FORMER CARNOTITE REDUCTION COMPANY SITE

EXCAVATION PLAN

**Subject: Former Carnotite Reduction Company Site Remediation
Stormwater Management Plan – Revision 1**

This revised version addresses your comments received by Tetra Tech on December 3, 2019 (see Attachment 14). The review comments and Tetra Tech's responses are summarized below:

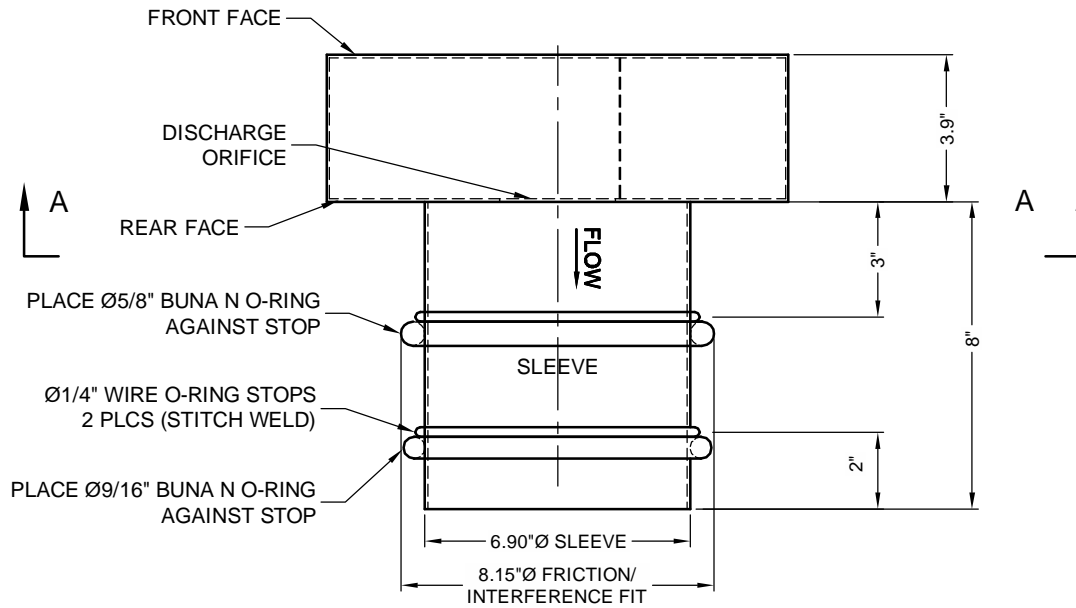
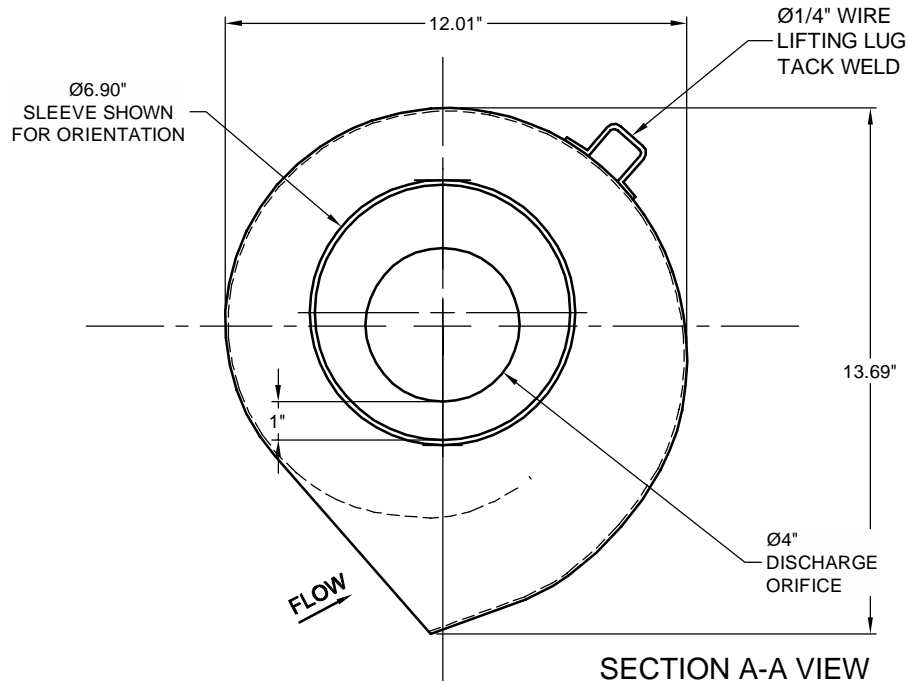
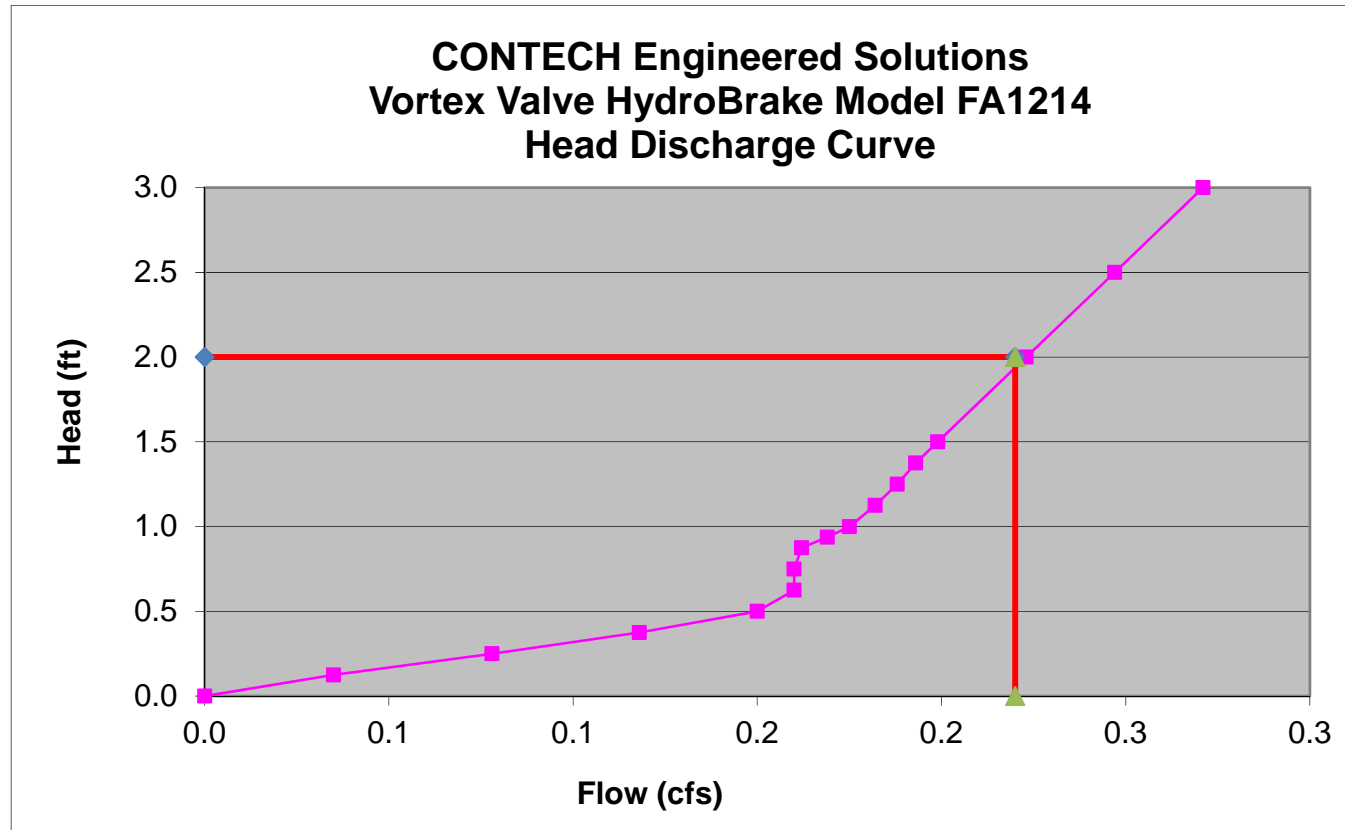
2. Attachment 5 Stormwater Calculations: Add a cut sheet and rating curve for a custom vortex restrictor that will discharge 0.22 cfs under the proposed head conditions.

Response: Revised submittal includes a cut sheet and a rating curve for a F1214 Vortex regulator with a 4" discharge orifice from Contech Engineered Solutions LLC, a City of Chicago approved vendor (see Attachment 16).
